and Management Parameters for 10 Mb/s Operation and Associated Power Delivery over a Single Balance

Cl 00 SC FM P 12 L 28 # i-9
 Anslow, Peter Ciena
 Comment Type E Comment Status A Editorial
 The Editor's note: "New front matter text needs review." should be removed.
 SuggestedRemedy
 Review the text and delete the note.
 Response Response Status C
 ACCEPT IN PRINCIPLE.
 Delete Editor's note on lines 28-31

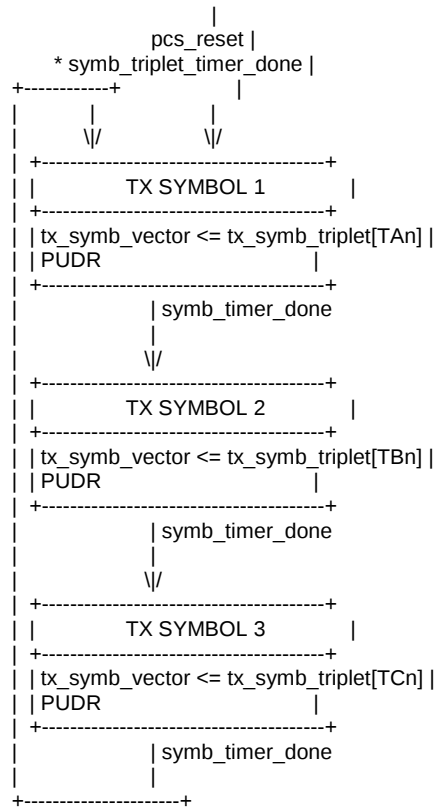
Cl 146	SC 146.3.2.1	P 135	L 22	# i-155
Zimmerman, George		ADI, APL Group, Aquantia, BMW, Cisco, Commscop		
Comment Type	E	Comment Status	A	Editorial
rem_rcvr_status is defined as OK or NOT_OK where the primitive is defined 146.2.7.1 and in the state diagram (Figures 146-14 and 146-15). Here it is defined as TRUE or FALSE.				
SuggestedRemedy				
Change TRUE to OK and change FALSE to NOT_OK				
Response		Response Status C		
ACCEPT.
